Proposal for draft amendments to Regulation No. 51

I. Proposal

II. Justification

Figure 1: The influence of acceleration delay

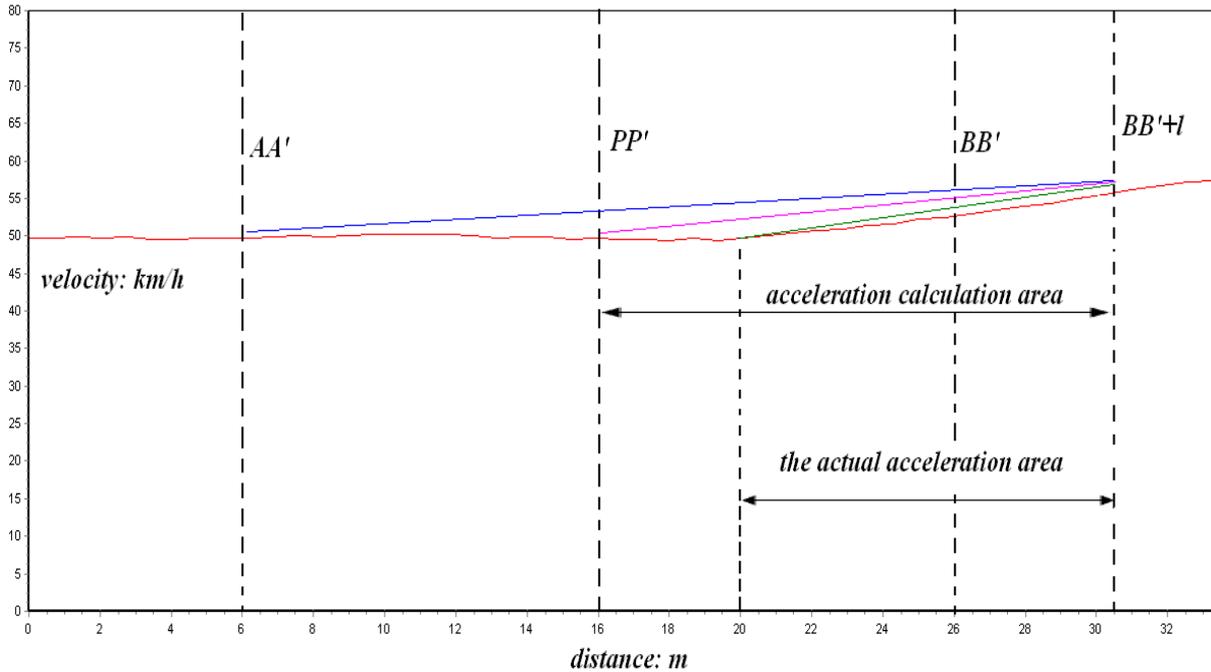
Conclusion: If the pre-acceleration is not used, vehicles with non-locked gear transmissions can not tested its' real acceleration, when the acceleration time delay is longer than 0.7 seconds. So in this situation, pre-acceleration of 4 meters is needed for making sure the real acceleration can be get. And the test accelerations $a_{\text{wot test}} = a_{\text{wot ref}}$ is related to the $k_p = 1 - (a_{\text{urban}} / a_{\text{wot ref}})$ weighting factor, and will influence the final result, so China think it's so important to get an exact and equitable acceleration when doing the test for automatic transmission vehicles.

Figure 2 Situation of exceed S and the deceleration delay of commercial vehicles

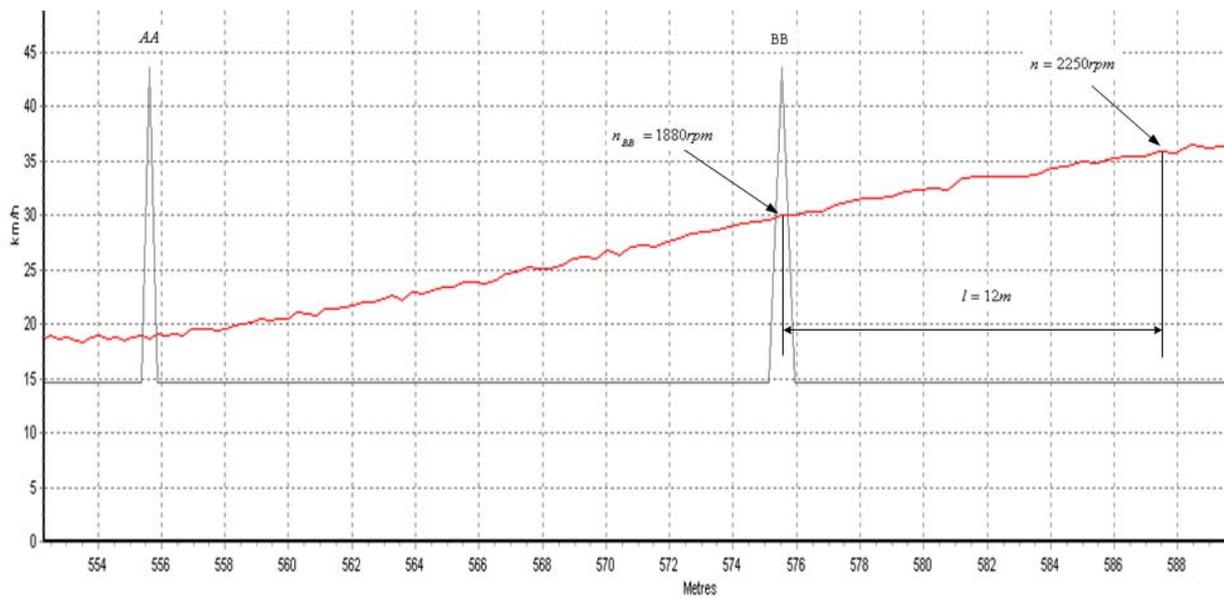
- ① Some vehicles especial the front engine disposal vehicles, even the $n_{BB'}$ can fulfil the target condition, but when the rear of the vehicle pass the BB line and the engine speed has exceeded the rated engine speed (S), so the report only contains the $n_{BB'}$ and $n_{AA'}$ is not enough.
- ② The condition of engine speed exceeds S in not a recommended working condition by manufacturers, so such kind of working condition should not be contained in our test procedure.

- ③ There is always a deceleration delay when we release the acceleration pedal, so the maximum engine speed is also not in the point when we release the acceleration pedal.

Figure 3 Flow chart for deciding the test gears

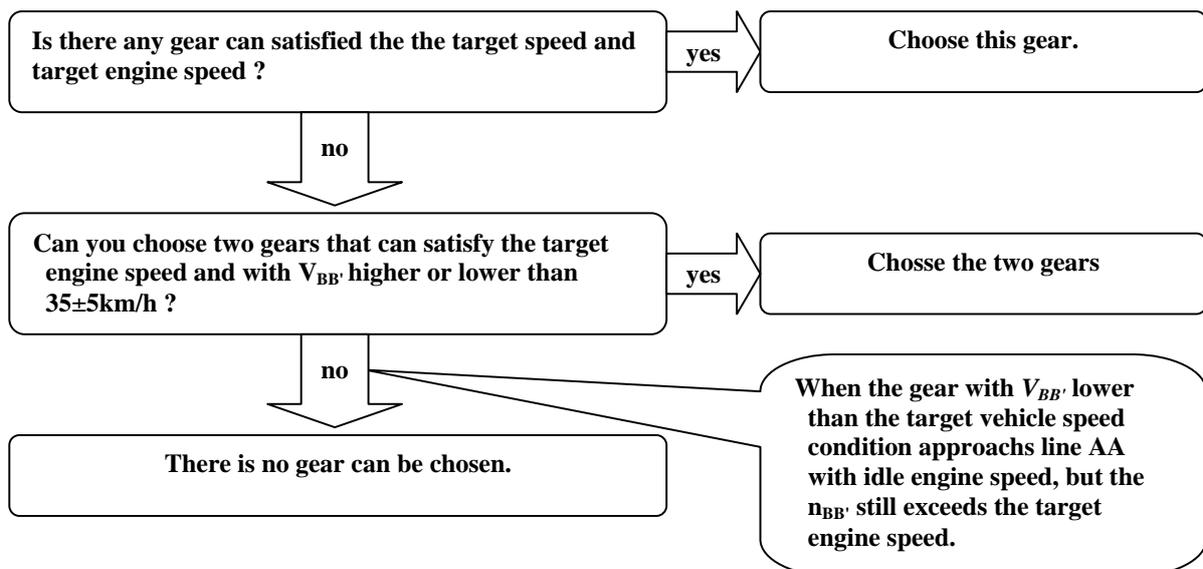
If more than one gear fulfils the target conditions select that gear which is closest to 35 km/h. If no gear fulfils the target condition for v_{test} two gears shall be tested, one above and one below v_{test} . **When the test is performed in the gear with the speed below v_{test} , if the engine speed $n_{BB'}$ still exceed the upper limit of the target engine speed attained with an approach speed corresponding to the idle speed, then the test will be performed only in gear with the speed above v_{test} .** The target engine speed shall be reached in any condition. **When testing in the selected gears, if the engine speed exceed the rated engine speed (S) during the test, the test data of this gear must be disregarded, then the next higher gear shall be used.**

Figure 4 Test conditions for vehicles

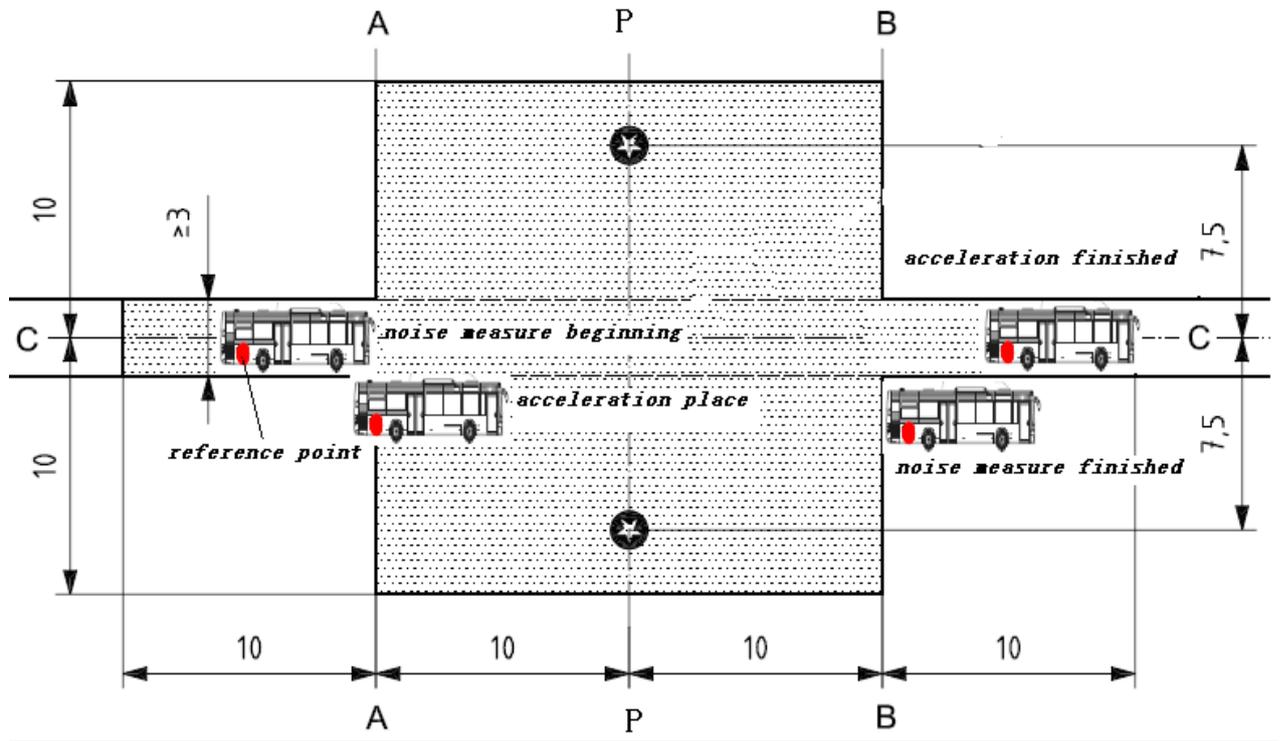
Conclusion: such kind of description “test the maximum A-weighted sound pressure level between the two lines AA' and BB'” make the test condition of vehicles so difficult, and the acceleration procedure is not corresponding to the noise measuring procedure. Such kind of description also makes it more hard to finish the test, especially when I ask you how you can make sure the noise you test is just between the two lines AA' and BB'? And it makes the test using sound level meters impossible, maybe the happiest ones are from the noise test equipment suppliers but make no sense to the final result.
